**NY Power  
Authority**

Crescent Hydroelectric Project, FERC Project No. 4678-052  
Vischer Ferry Hydroelectric Project, FERC Project No. 4679-049  
Response to ISR Comments and Submission of Revised Study Plan

## **Attachment 3 – Proposed Second Year Water Quality Study Plan**

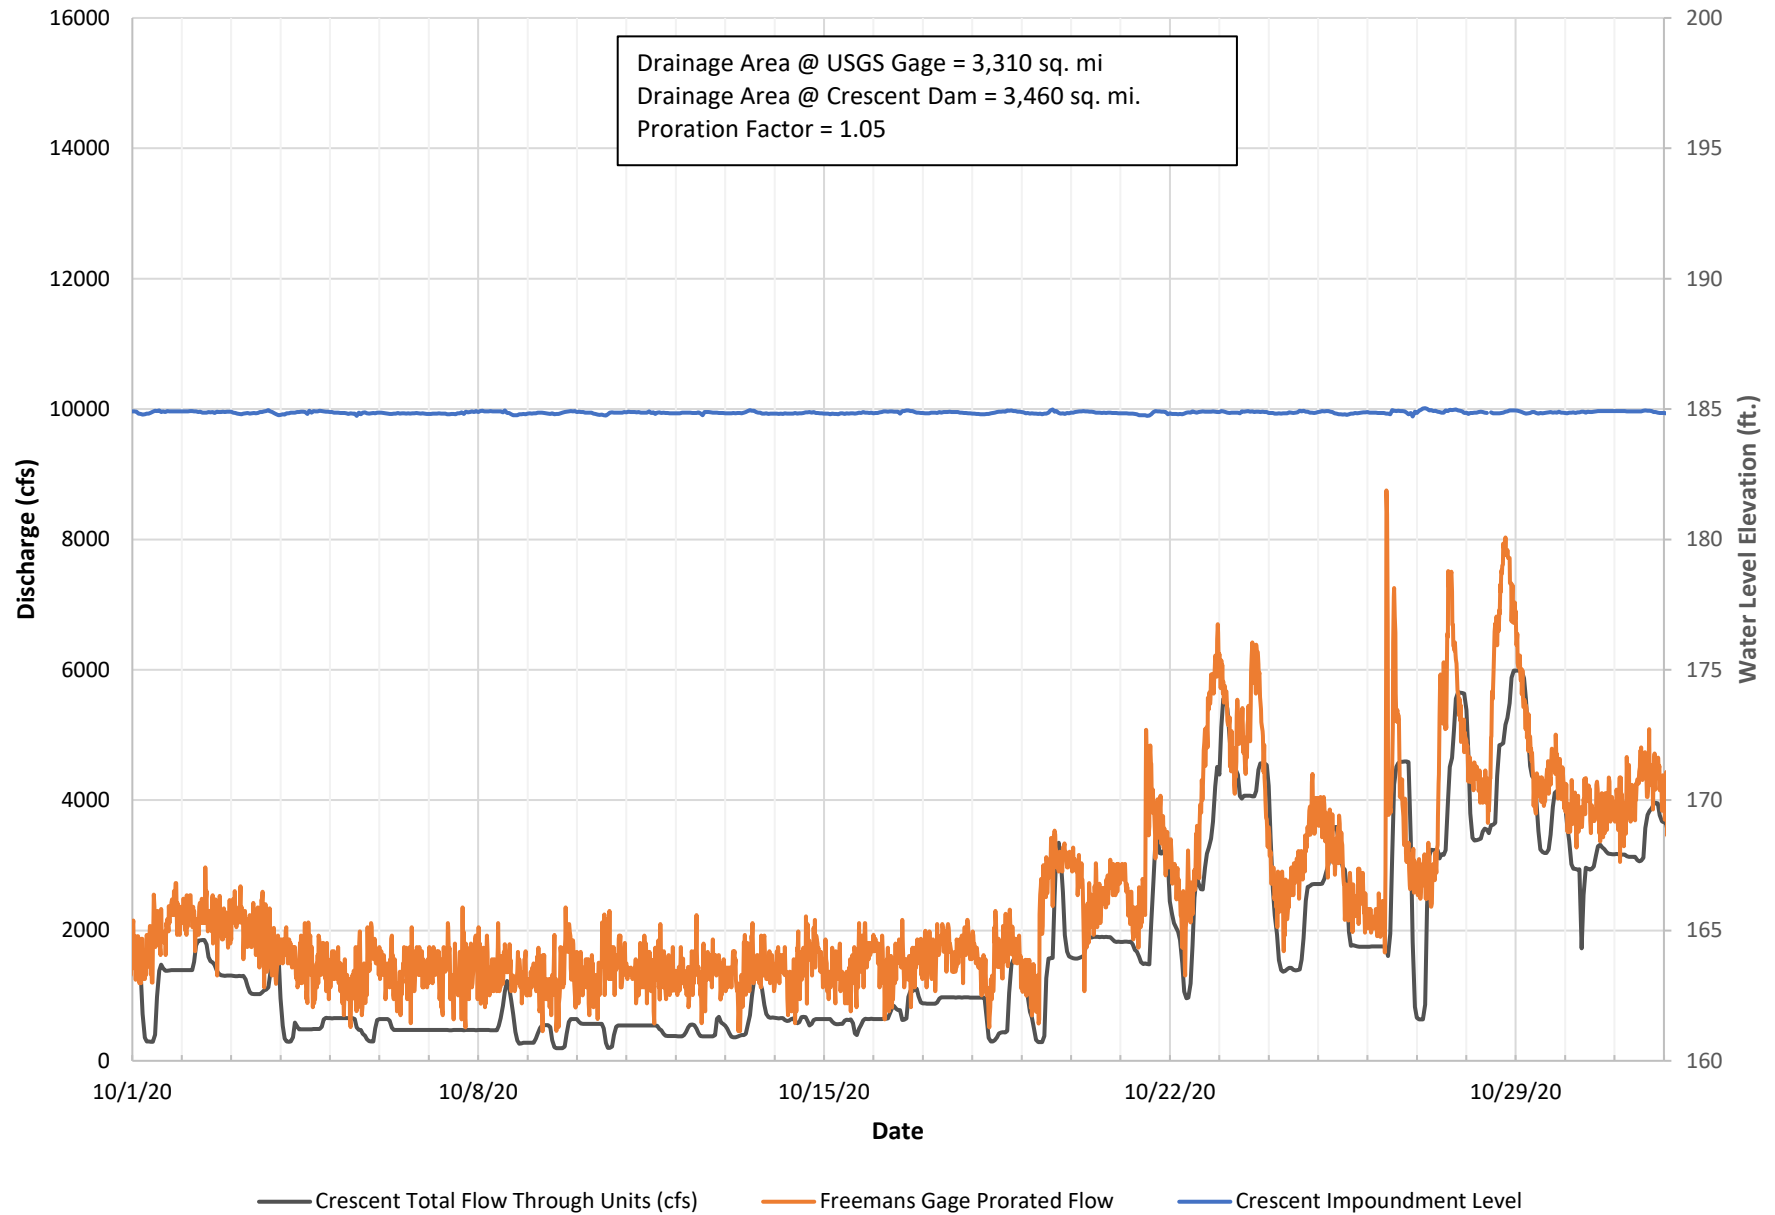
**Comment 2:** NYSDEC (4/16/2021) requests that the Power Authority graph the total prorated flow that passes the Projects with generation flow included. NYSDEC notes that this will provide a more complete understanding of flows at the Projects, how they are being utilized, and confirm that the minimum flows are also being provided.

**Response 2:** The Power Authority has developed the requested graphs of prorated flows (based on drainage area) at the Vischer Ferry and Crescent Projects, using the flow data from the upstream USGS gage (no. 01354500) on the Mohawk River at Freeman's Bridge (Attachment 2). The drainage area at the USGS gage is 3,310 sq. mi. and proration factors used were 1.02 for the Vischer Ferry Project and 1.05 for the Crescent Project. Also shown on the flow graphs is elevation data for the two Project impoundments. As shown, impoundment fluctuations were minimal throughout the study period, demonstrating that the Projects were operating as run-of-river throughout the study season.
